#### ADDENDUM NO. 7

**June 6, 2022**

# LIBERTY INTERMEDIATE SCHOOL ADDITIONS AND RENOVATIONS

This Addendum consists of Pages ADD 7-1 through ADD 7-4 and attached Addendum No. 7 from Gibraltar Design dated June 6, 2022 and consisting of 5 pages and 75 drawings.

© GIBRALTAR DESIGN SHEET MP102

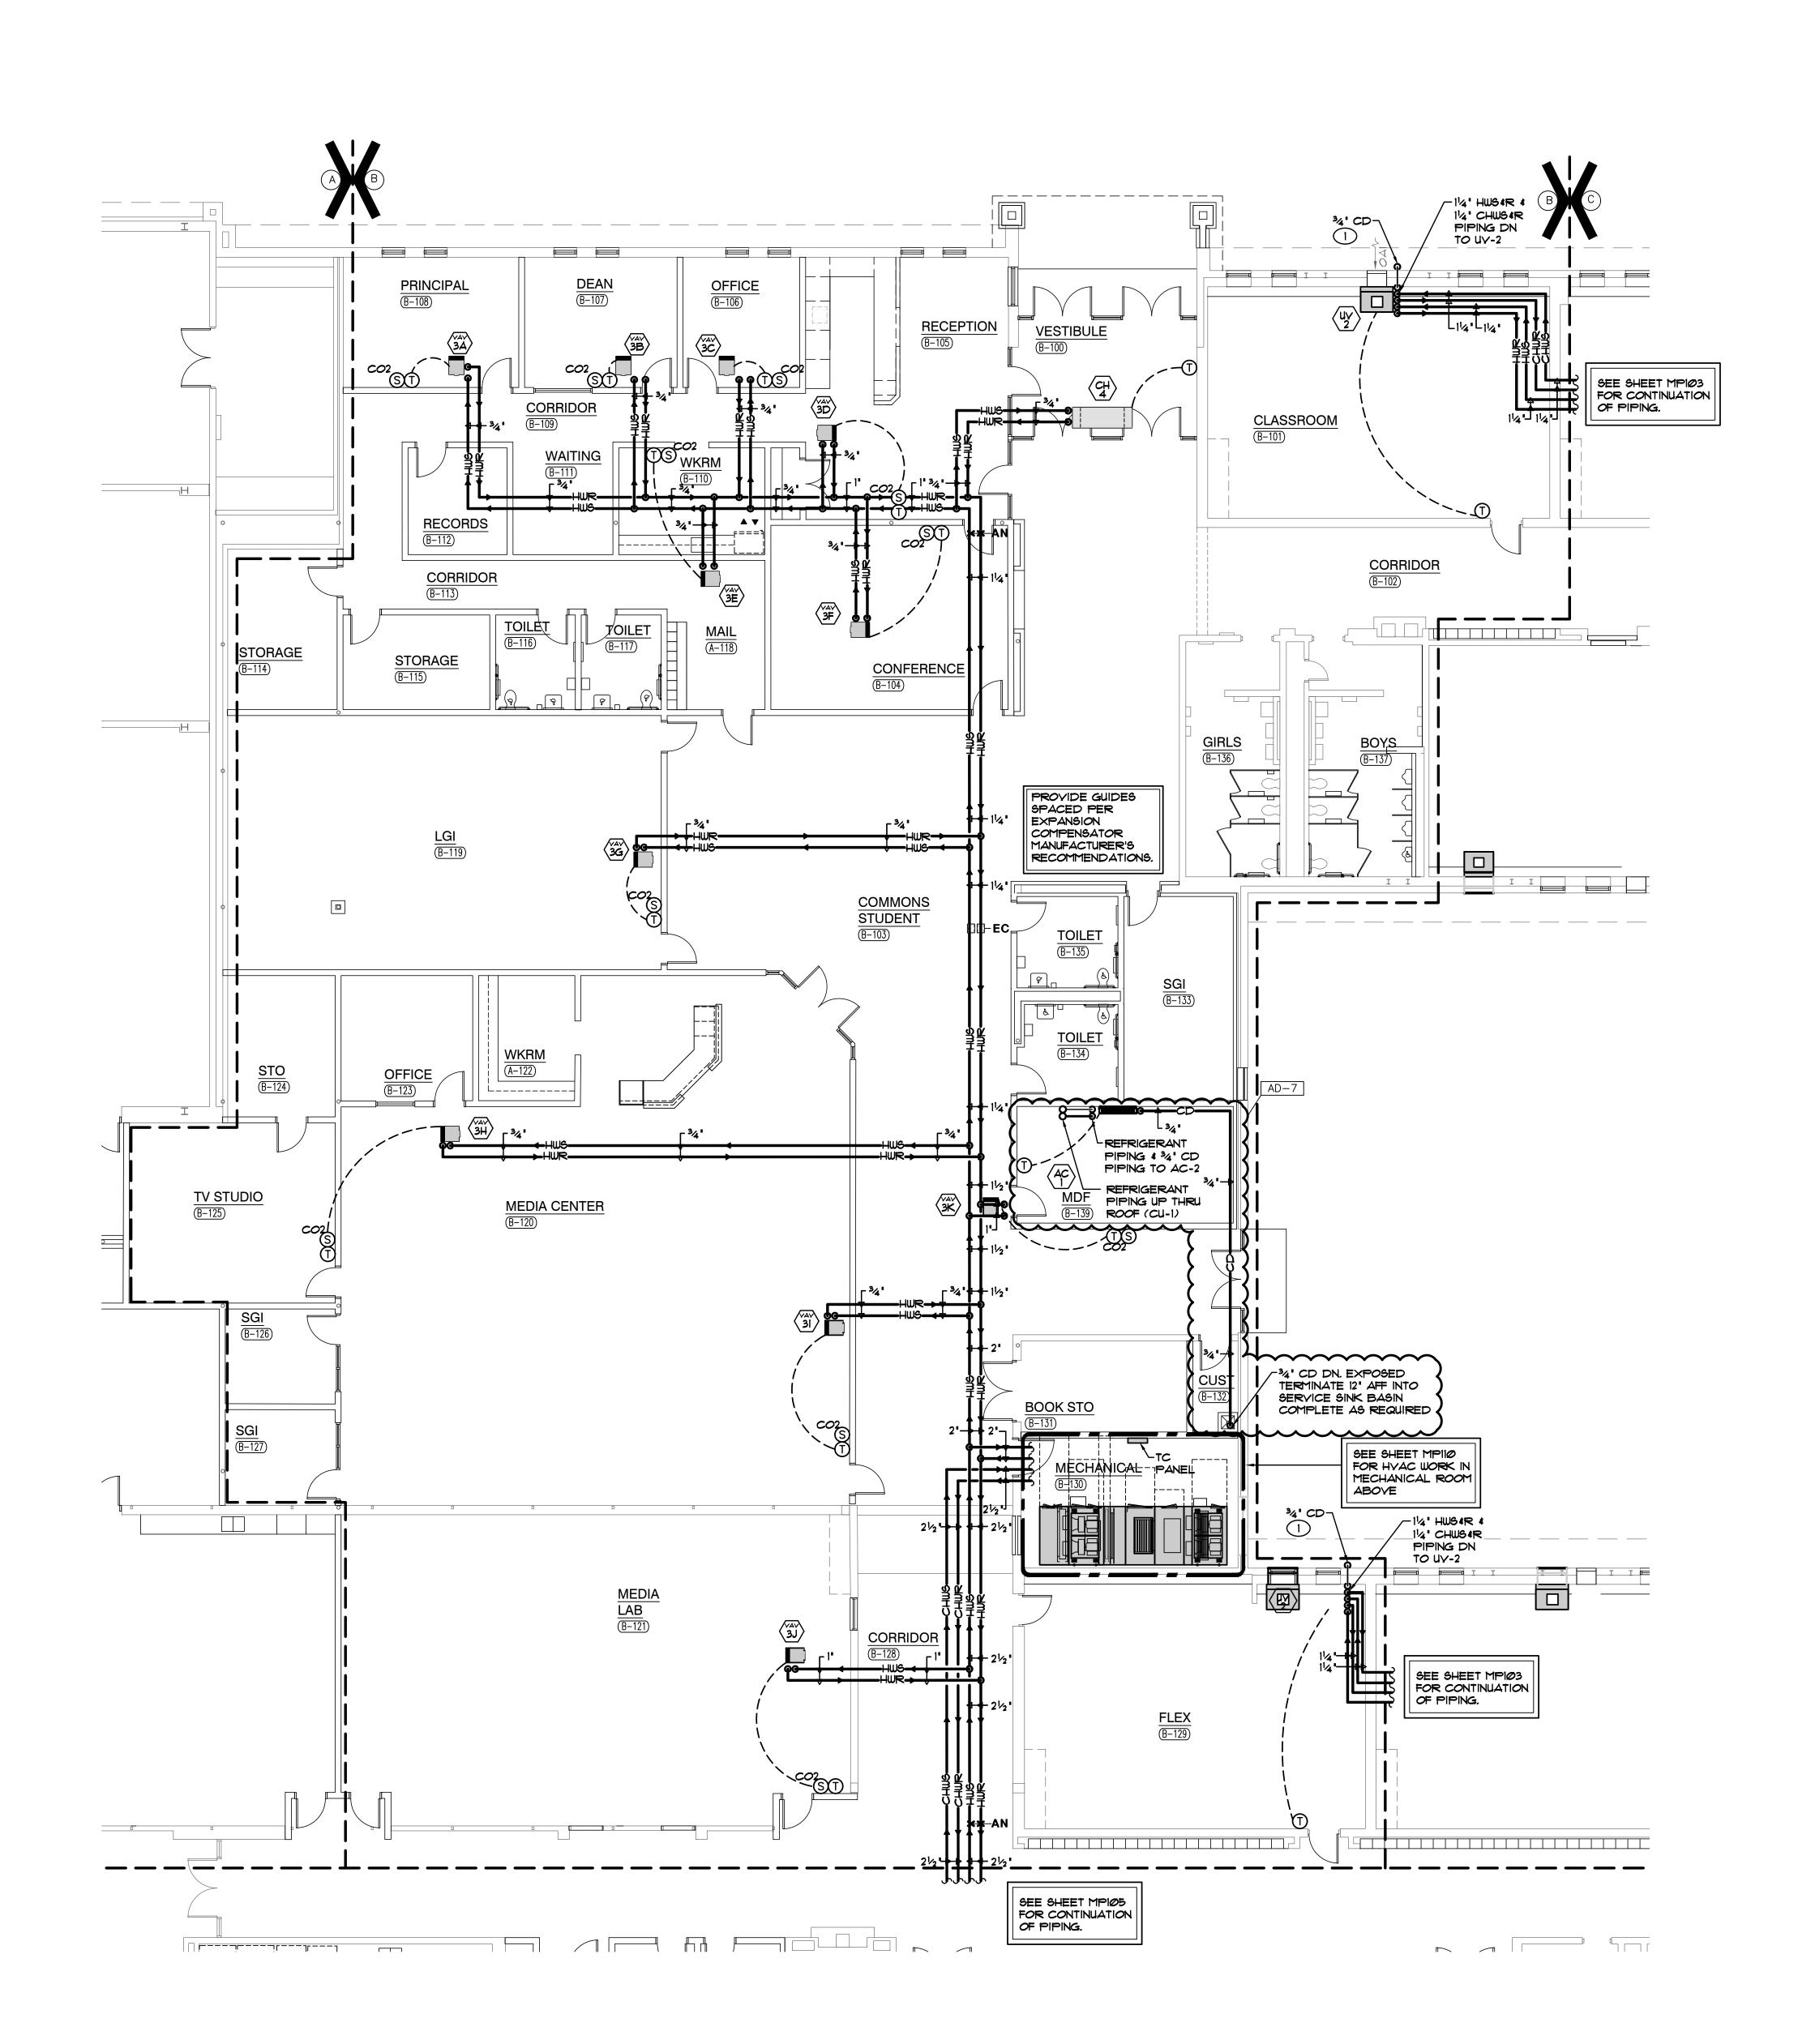
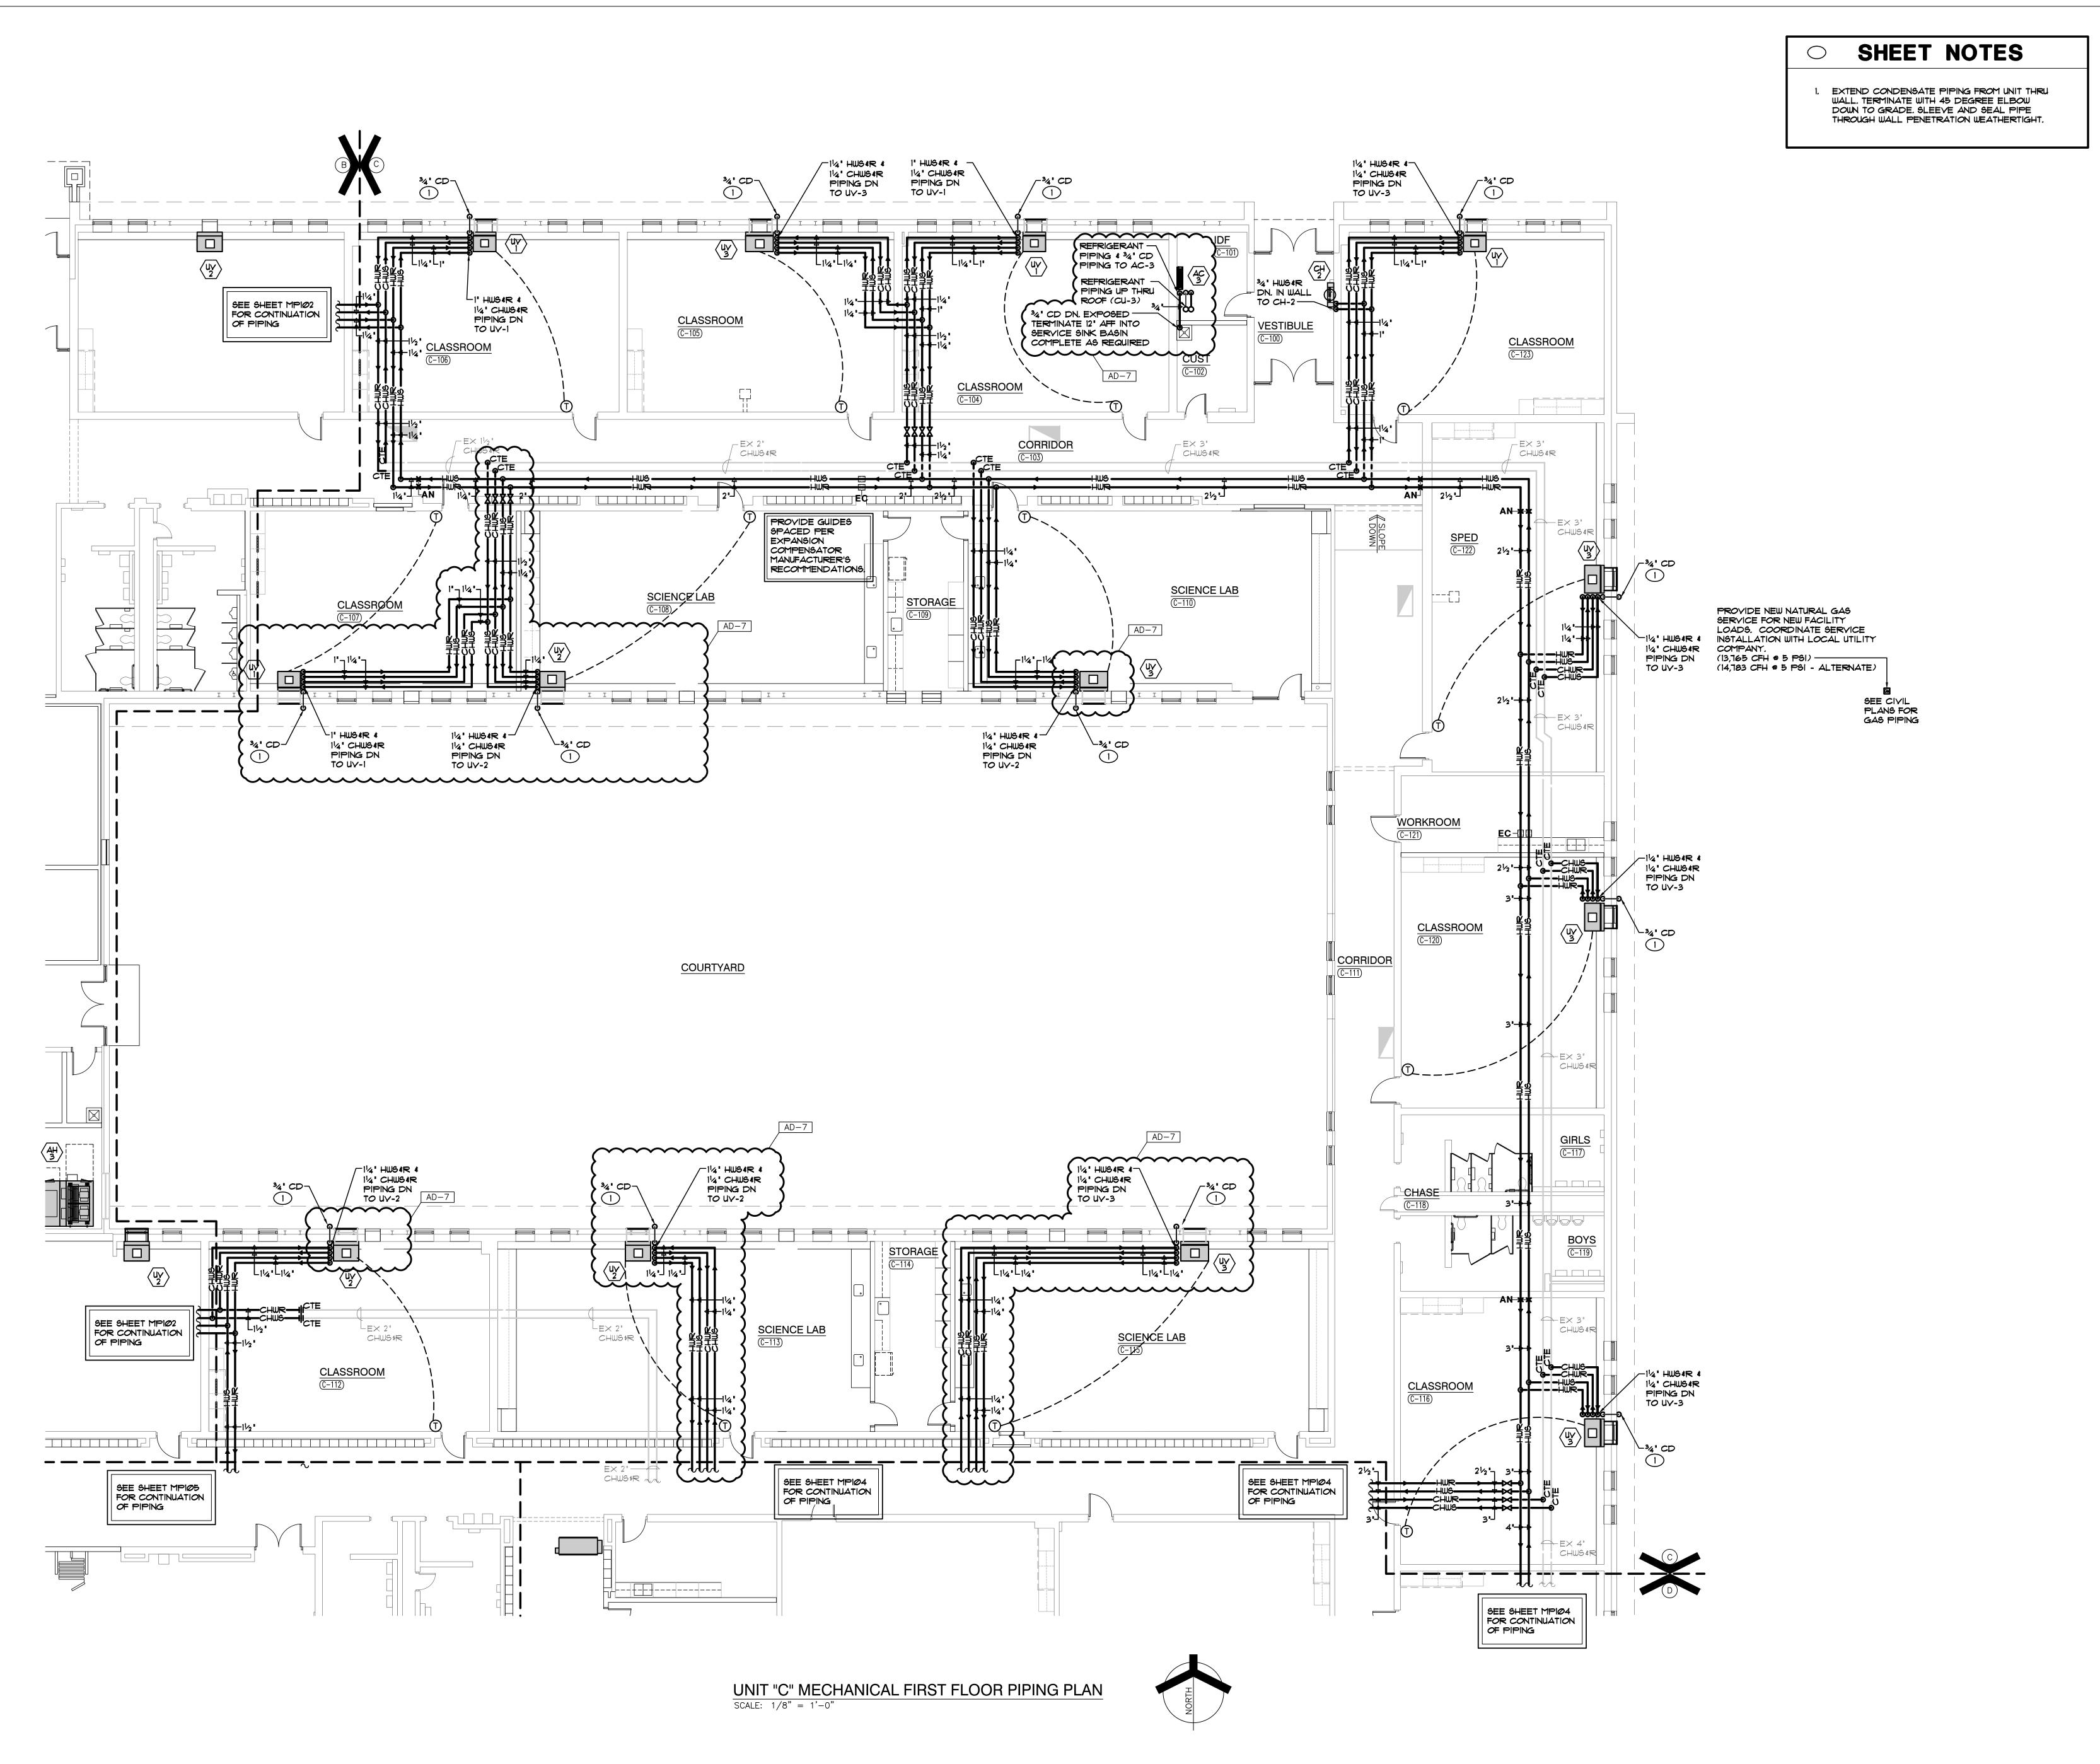
- A. Refer to revised full-size drawing included in this Addendum, for the following revisions:
  - 1. Added AC Unit, Refrigerant piping, and Condensate piping to MDF room.

MP103

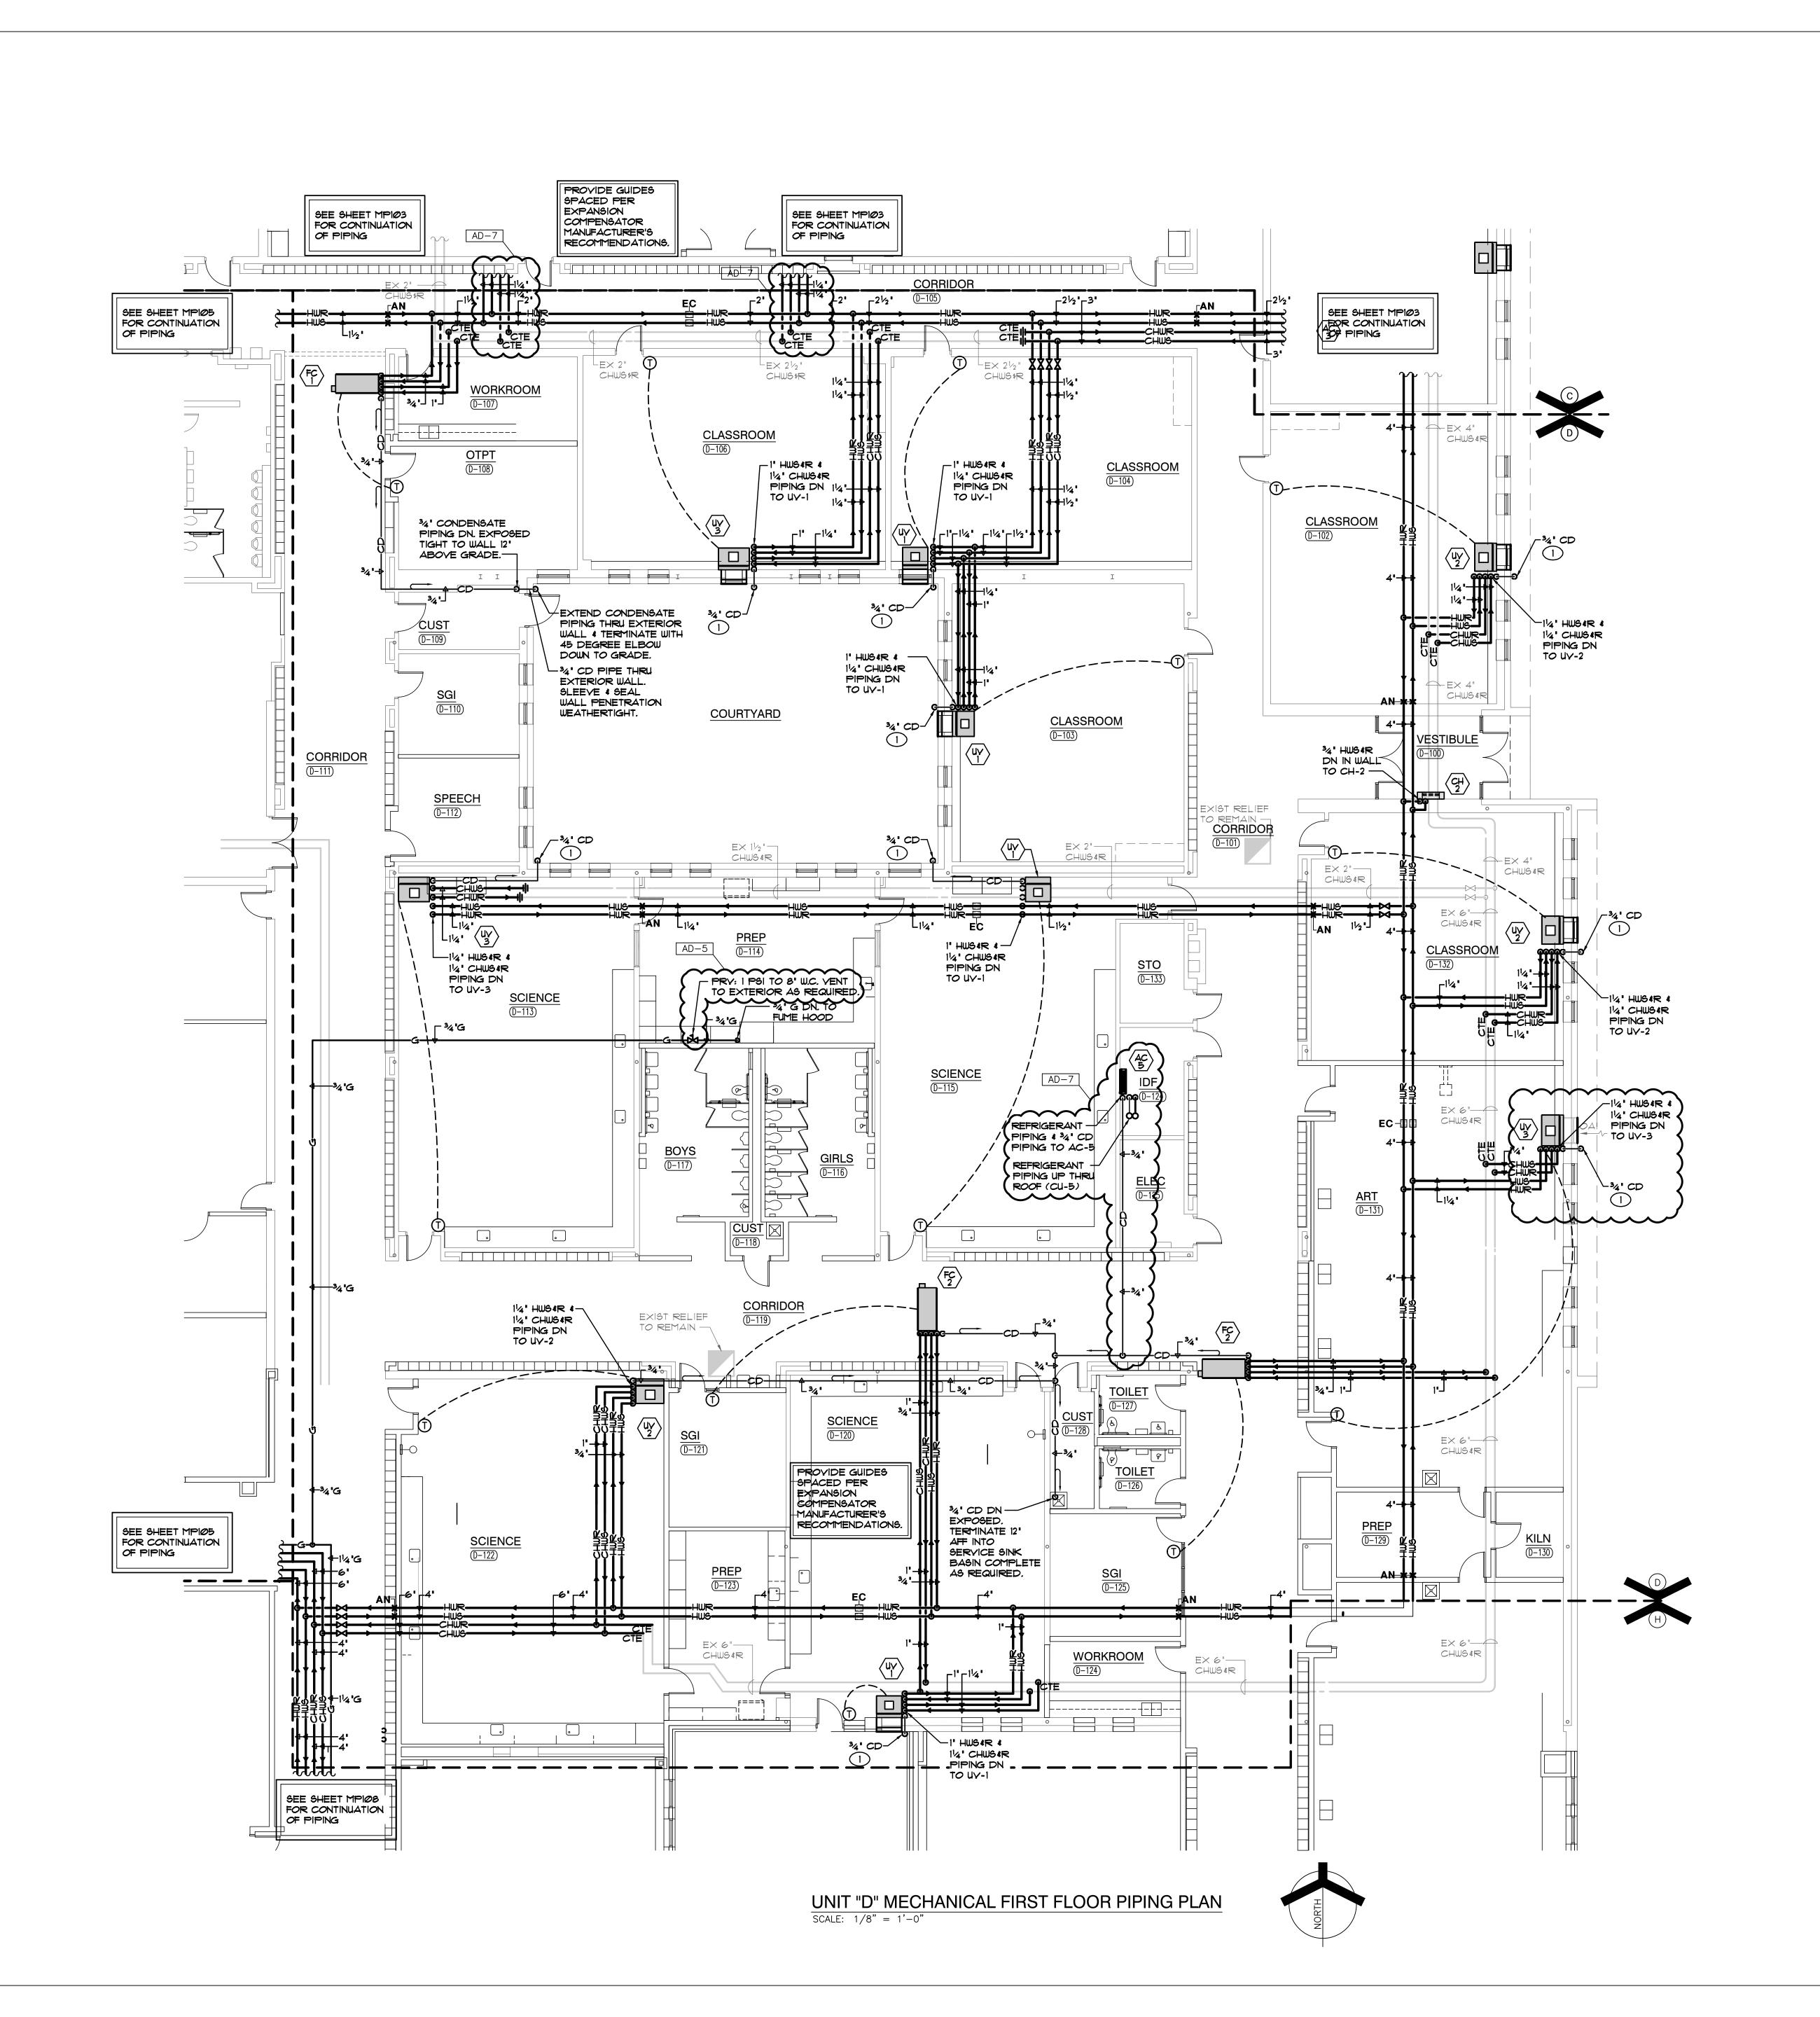
- A. Refer to revised full-size drawing included in this Addendum, for the following revisions:
  - 1. Added AC Unit, Refrigerant piping, and Condensate piping to IDF room.
  - 2. Revised pipe routing to Unit Ventilator.
